Errata

January 26, 2016

The 2nd Ed. of *Old-Time Telephones* is remarkably free of errors considering the huge amount of technical information that is presented, including many tables and original diagrams. Corrections were made for the second printing of the 1st Ed. and again for the 2nd Ed. Subsequently, *Old-Time Telephones* was used as the text for an on-line course called Telephony 101, and from time to time it is discussed on line with telephone collectors. This attention has flushed out a few more errors, and all of the errors identified to date are identified below.

Fig. 17-14 Corrected

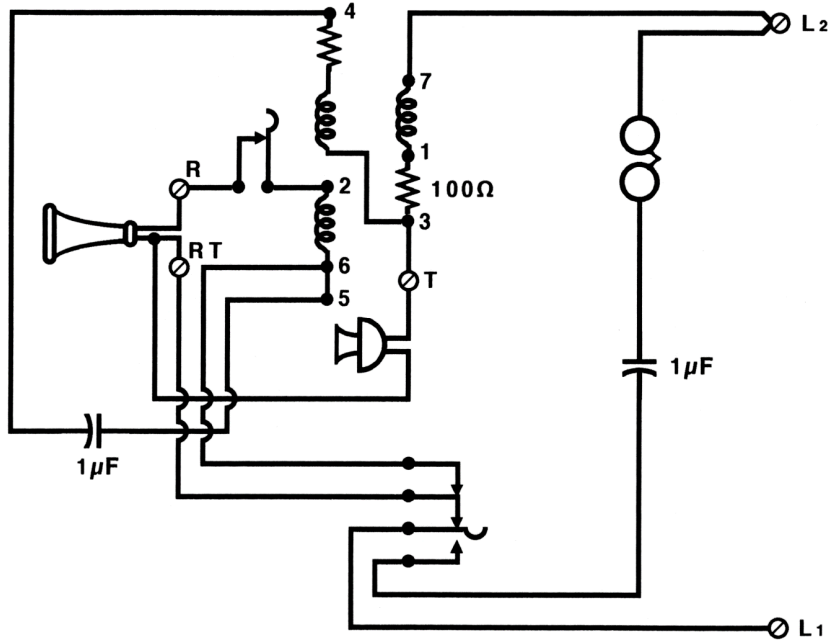
- Page 137. In Fig. 17-14, interchange the labels L1 and L2 (modified figure provided below).
- Page 140. In Fig. 17-18, interchange the labels 8 and 6 (modified figure provided below).

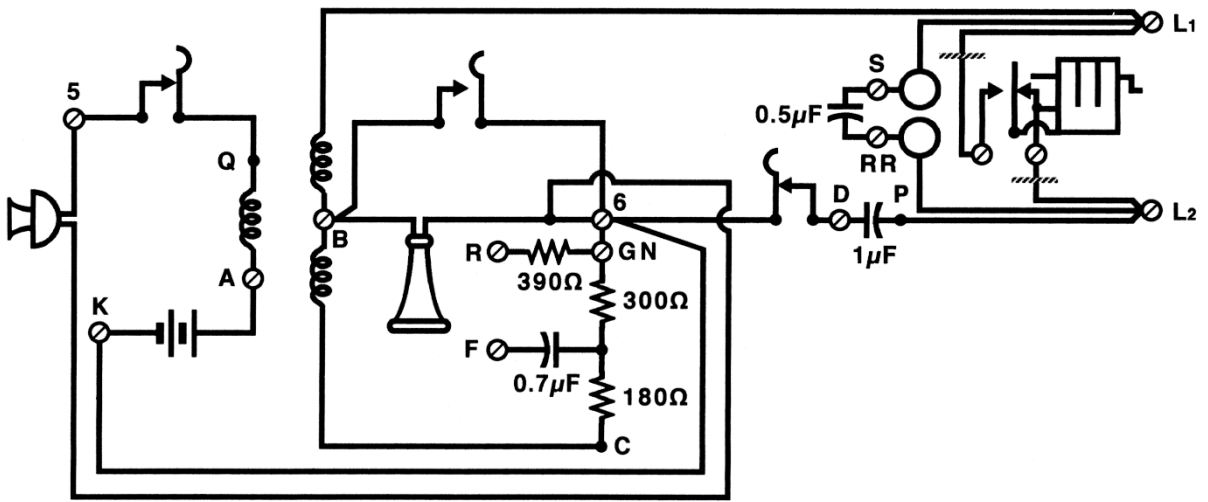
- Page 151. In Fig. 18-7, add two terminal labels, L1 and GND (modified figure provided below).
- Page 153. Seven lines down, replace “rear of the phone” with “front of the phone.”

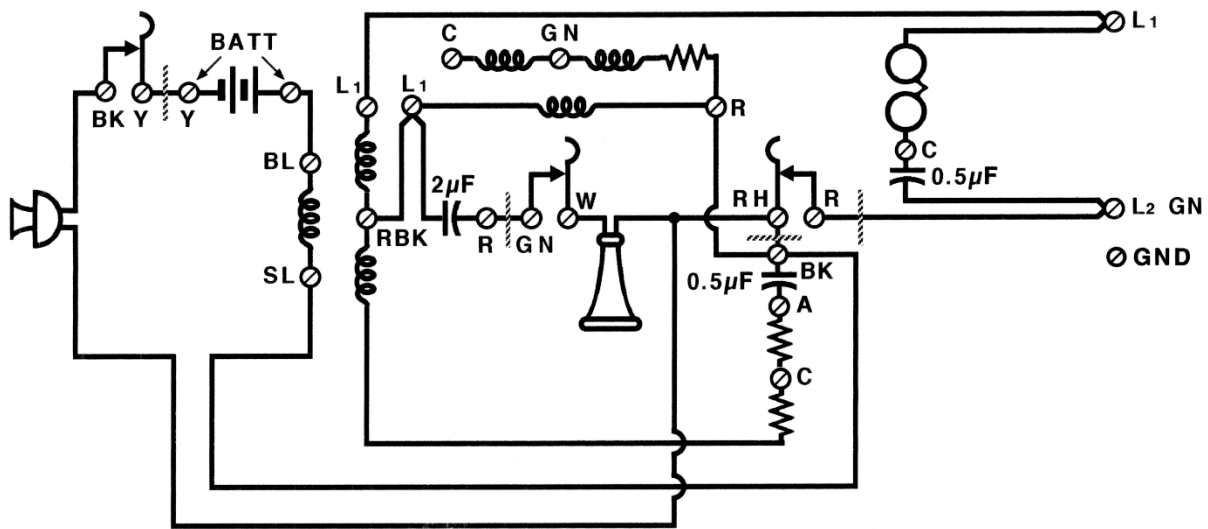
- Page 154. In Fig. 18-9 at terminal Q, replace the symbol for a screw terminal with the symbol for a solder terminal (modified figure provided below).

Fig. 18-19 Improved

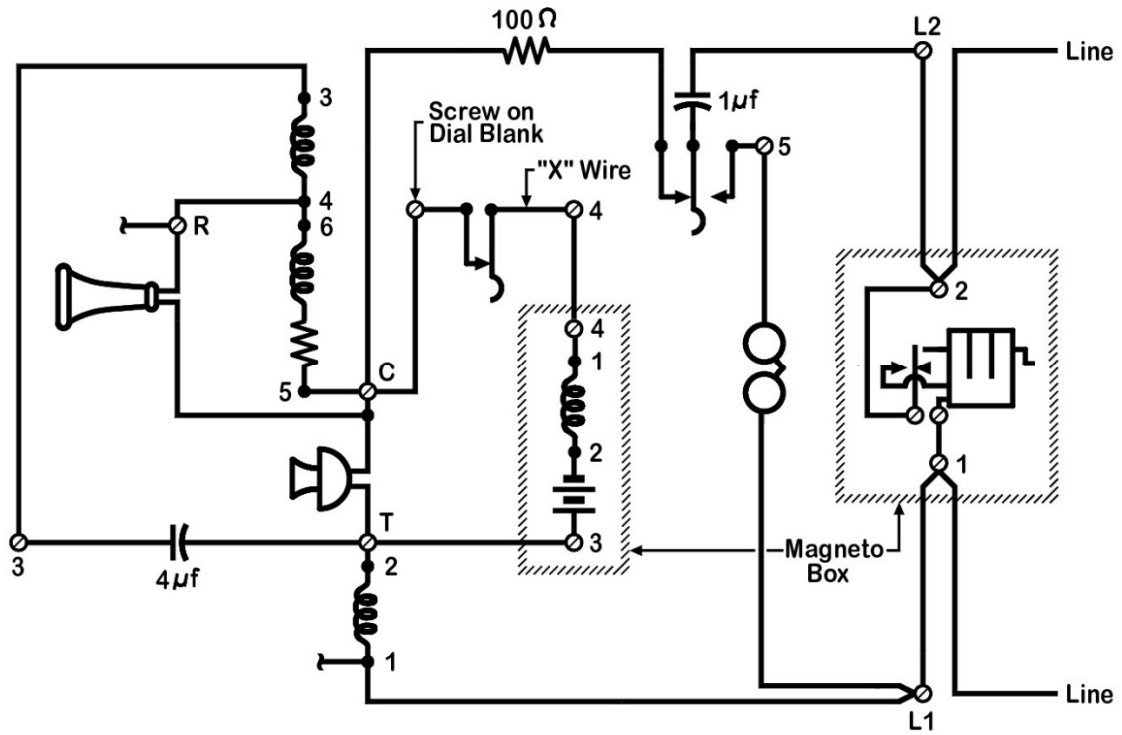
- Page 160. In Table 18-4, replace “2,500” with “1,250” as the total impedance in ohms.
- In Fig. 18-19, improved terminal markings are included in the Magneto Box (modified figure provided below).

Fig. 22-7 Improved

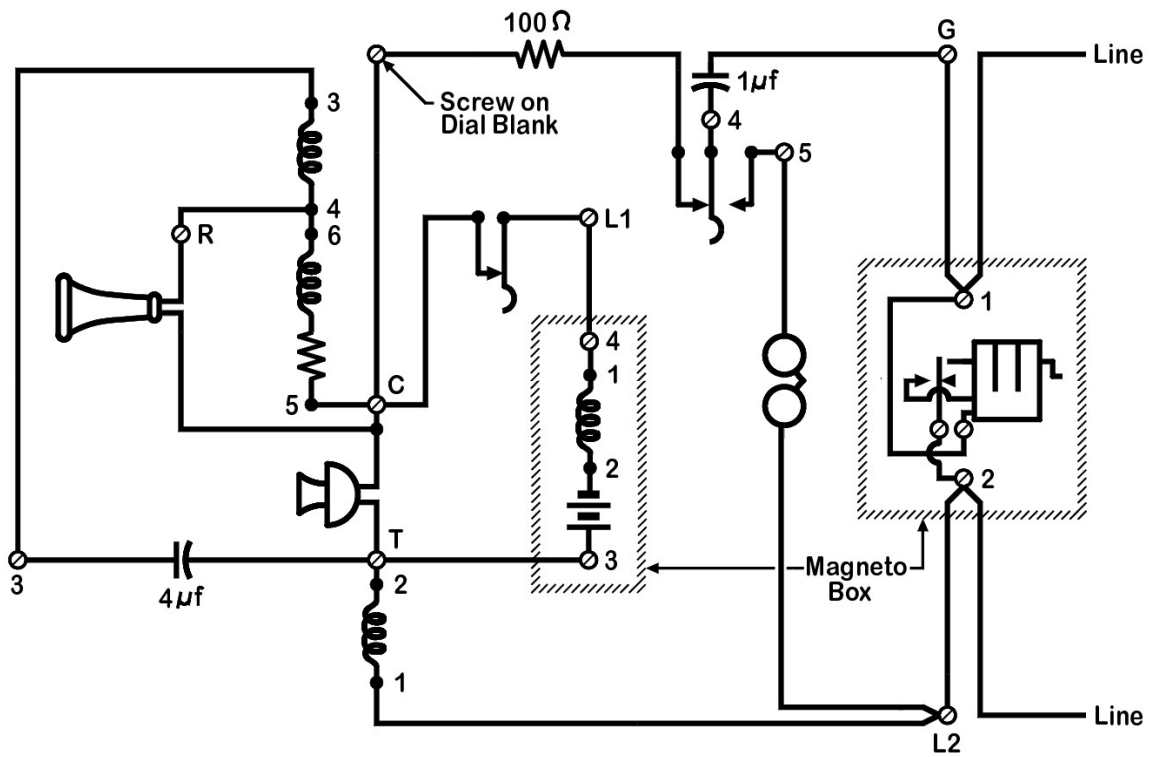
- Page 208. In Fig. 22-7, improved terminal markings are included in the Magneto Box (modified figure provided below).
- Page 216. Eight lines down under Table 22-1, replace “premise” with “premises.”
